CROSSROADS MIXED USE FILING NO. 2

CONSTRUCTION PLANS

V3_Construction Drawings_comments.pdf Markup Summary

CAUTION

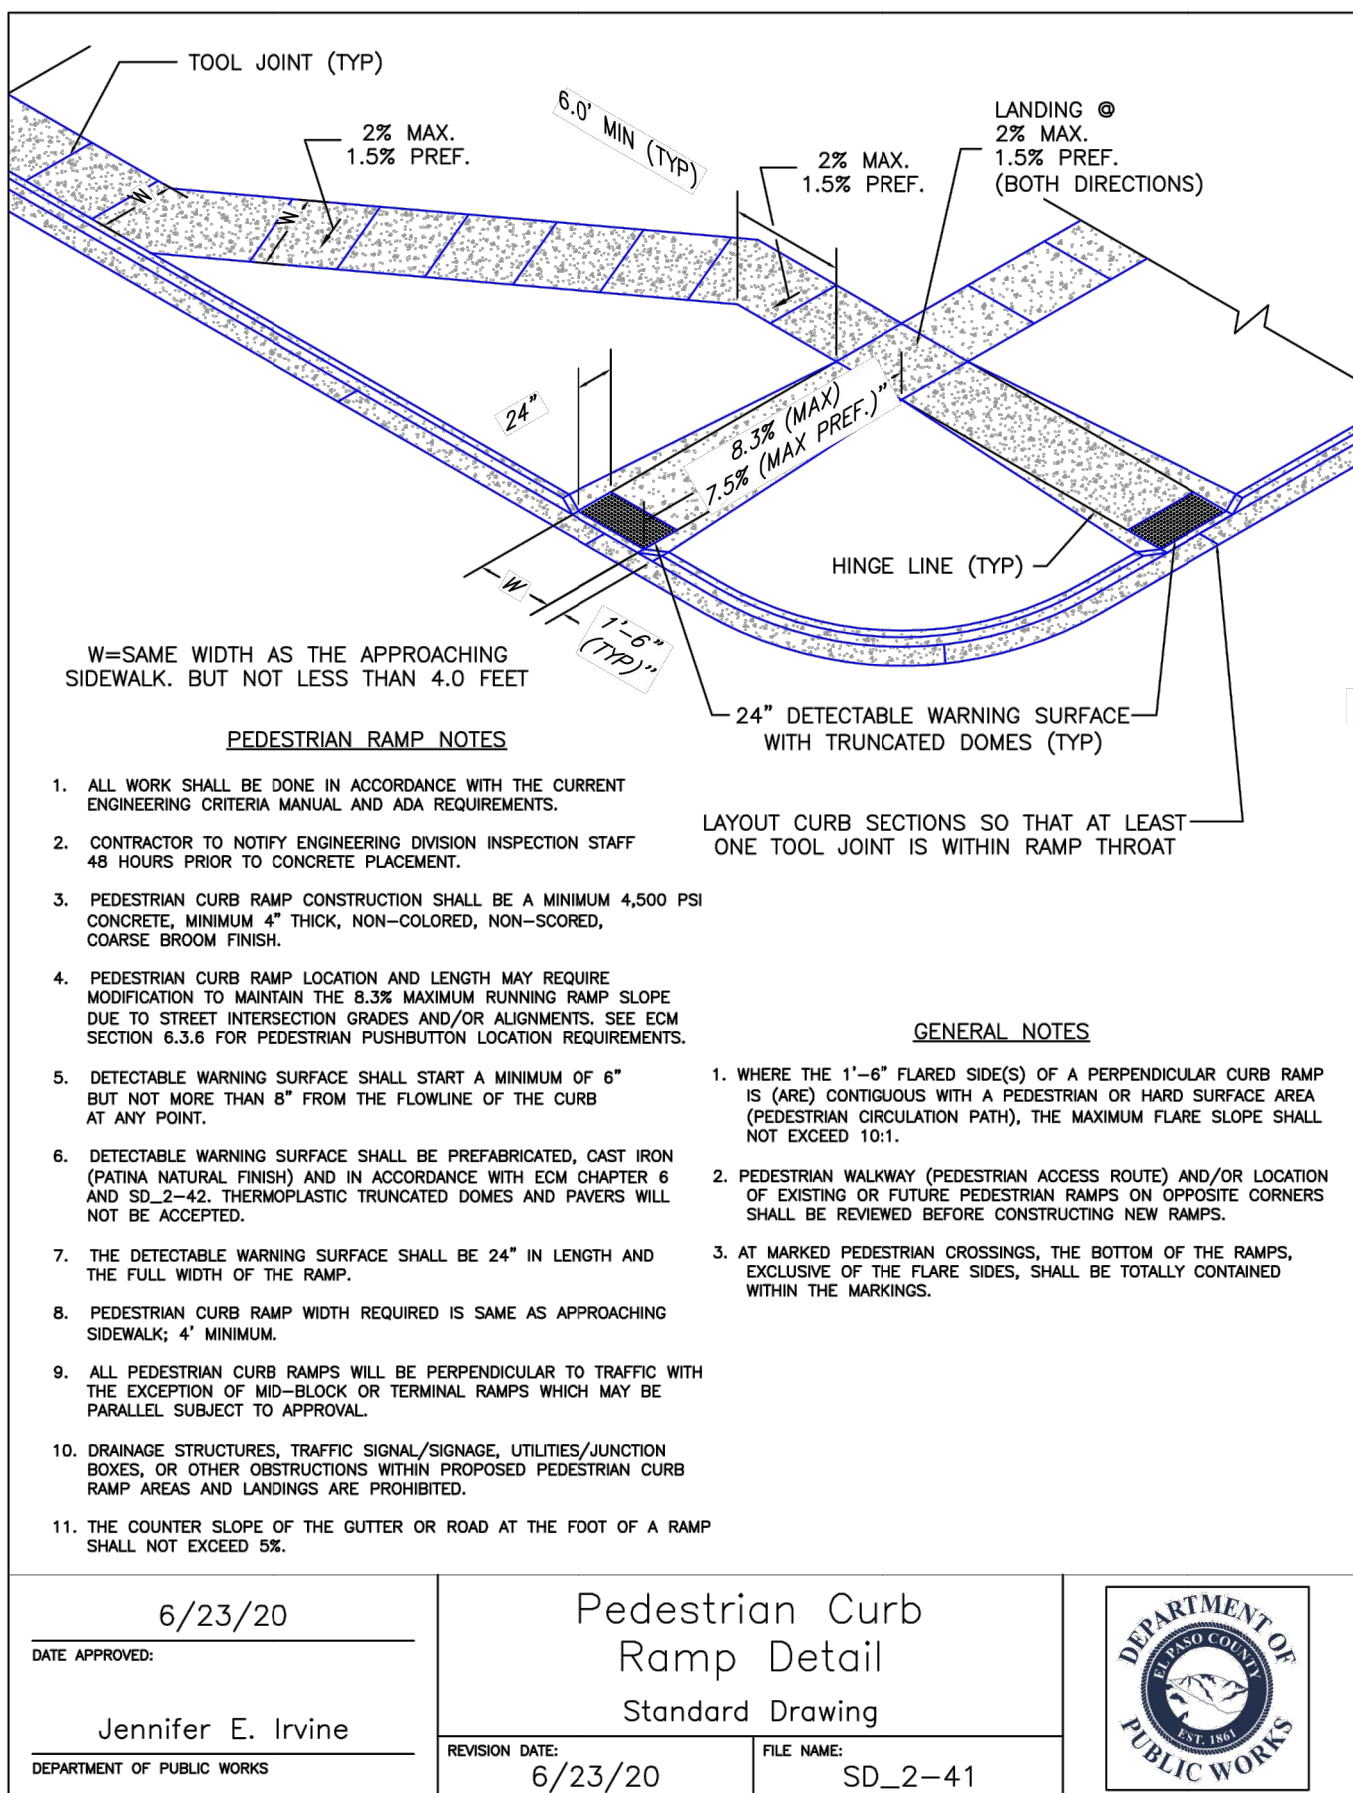
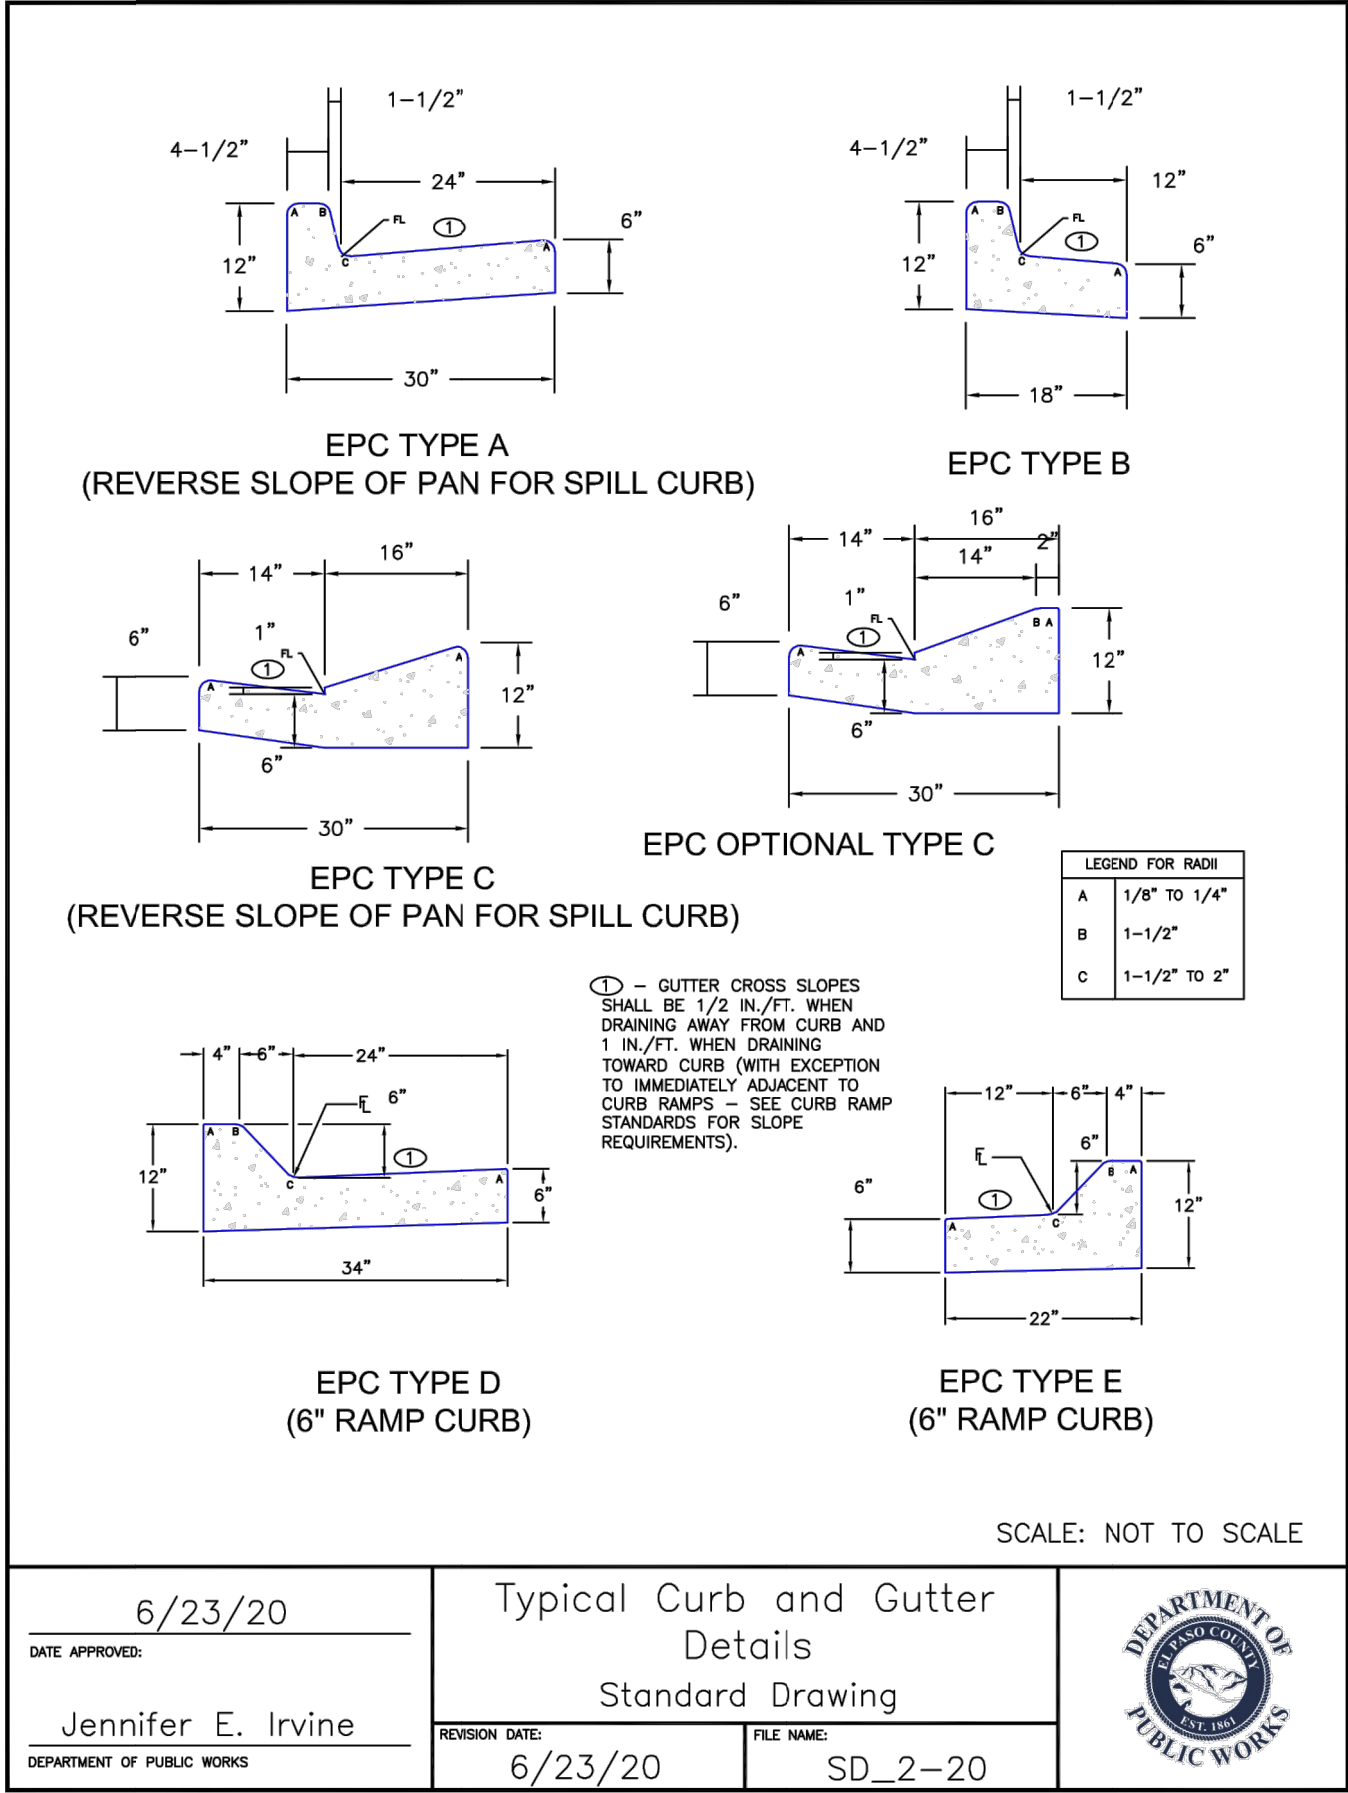
Unresolved from review 1 and 2. Update cross section to provide sidewalk on both sides per the approved deviation request filed under PCD File No SP2011.

Deviation was denied. Please update to include sidewalk on appropriate places.

Drawings have been updated to include the sidewalks on each side as in appropriate places with ramps.

Unresolved from review 1 and 2. Update cross section to provide sidewalk on both sides per the approved deviation request filed under PCD File No. SP2011.

Deviation was denied. Please update to include sidewalk on appropriate places.
